QUALITY ASSURANCE -- NON-CONFORMANCE REPORT

Location: Changxing Island, Shanghai, China**Report No:** NCR-000817**Prime Contractor:** American Bridge/Fluor Enterprises, a JV**Date:** 28-Jul-2010**Submitting Contractor:** Zhenhua Port Machinery Company, Ltd (ZPMC), Changxing Island**NCR #:** ZPMC-0779**Type of problem:**

Welding	Concrete	Other	
Welding	Curing	Procedural	Bridge No: 34-0006
Joint fit-up	Coating	Other	Component: Suspender Bracket SB88W
Procedural	Procedural	Description: Missed MT cracks were repaired without CWR

Reference Description: Fifteen (15) Transverse Cracks were discovered by MT testing after ZPMC had accepted and tested this weld; Subsequent repairs made without Engineer's approval

Description of Non-Conformance:

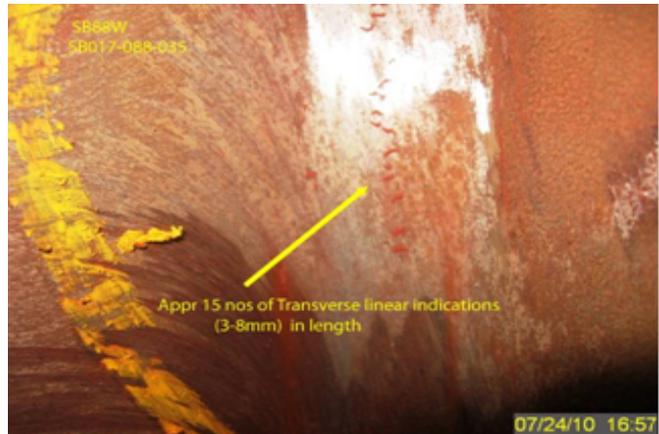
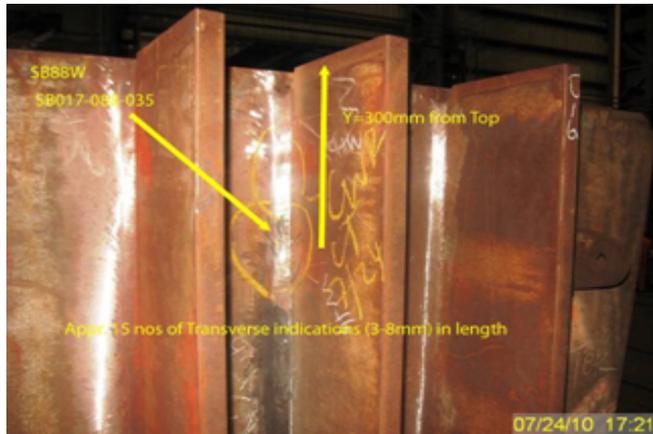
During the Quality Assurance (QA) of Magnetic particle Testing (MT) review of welds located on OBG Suspender bracket SB88W for Segment 10AW, this QA Inspector discovered the following issue on July 24, 2010.

- Fifteen (15) transverse cracks that measured approximately 3mm to 8mm in length.
- The weld is identified as SB017-088-035.
- The weld is a fillet weld connecting the Centre web plate to the Stiffener.
- These cracks are located Y=300mm from top of the centre web plate.
- The OBG Suspender Bracket is located in BAY#19.
- These cracks are clearly marked on the material on/near the weld.
- This weld joint is designated as Non-Seismic performance critical (Non-SPCM) weld member.
- The Notice of Witness Inspection Number (NWIT) is 006272.
- These cracks are located within the area that has been previously tested and accepted by ZPMC Quality Control (QC) personnel.

Subsequently, on July 28, 2010, QA observed that the repairs were made without prior Engineer's approval or an approved Critical Weld Repair (CWR).

Special Provisions Section 8.3 – “Quality Control (QC) shall be the responsibility of the Contractor. As a minimum, the Contractor shall perform inspection and testing of each weld joint prior to welding, during welding, and after welding as specified in this section and to ensure that materials and workmanship conform to the requirements of the contract documents.”

AWS D1.5 (02) Section 6.26.2 – “Welds that are subject to MT in addition to visual inspection shall have no cracks.

AWS D1.5 2002 section 3.7.4 specifies “Prior approval of the Engineer shall be obtained for repairs to base metal (other than those required by 3.2), repair of major or delayed cracks, repairs to ESW and EGW welds with internal defects, or for a revised design to compensate for deficiencies.”

Reference Resolution: ZPMC has repaired these cracks and is providing the NDT performed after to show that the repair was successful. ZPMC has repaired these cracks and is providing the NDT performed after to show that the repair was successful. In order to decrease missed indications, ZPMC QA will conduct refresher training with its inspectors and continue to monitor inspector performance. Based on this ZPMC requests closure of this NCR.

The proposed resolution is acceptable. This NCR is considered closed.

Description of Non-Conformance:

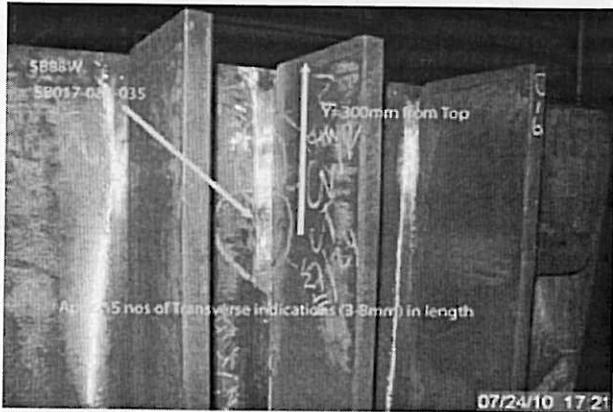
During the Quality Assurance (QA) of Magnetic particle Testing (MT) review of welds located on OBG Suspender bracket SB88W for Segment 10AW, this QA Inspector discovered the following issue on July 24, 2010.

- Fifteen (15) transverse cracks that measured approximately 3mm to 8mm in length.
- The weld is identified as SB017-088-035.
- The weld is a fillet weld connecting the Centre web plate to the Stiffener.
- These cracks are located Y=300mm from top of the centre web plate.
- The OBG Suspender Bracket is located in BAY#19.
- These cracks are clearly marked on the material on/near the weld.
- This weld joint is designated as Non-Seismic performance critical (Non-SPCM) weld member.
- The Notice of Witness Inspection Number (NWIT) is 006272.
- These cracks are located within the area that has been previously tested and accepted by ZPMC Quality Control (QC) personnel.

Subsequently, on July 28, 2010, QA observed that the repairs were made without prior Engineer's approval or an approved Critical Weld Repair (CWR).

Special Provisions Section 8.3 – “Quality Control (QC) shall be the responsibility of the Contractor. As a minimum, the Contractor shall perform inspection and testing of each weld joint prior to welding, during welding, and after welding as specified in this section and to ensure that materials and workmanship conform to the requirements of the contract documents.”

AWS D1.5 (02) Section 6.26.2 – “Welds that are subject to MT in addition to visual inspection shall have no cracks.

AWS D1.5 2002 section 3.7.4 specifies “Prior approval of the Engineer shall be obtained for repairs to base metal (other than those required by 3.2), repair of major or delayed cracks, repairs to ESW and EGW welds with internal defects, or for a revised design to compensate for deficiencies.”

Repair said cracks and perform NDT required to verify weld quality.

Contractor supplied post repair NDT documentation verifying weld conforms with Contract weld quality requirements. An internal NCR was also issued by ZPMC in regards to this issue, and refresher training was provided to NDT technicians.
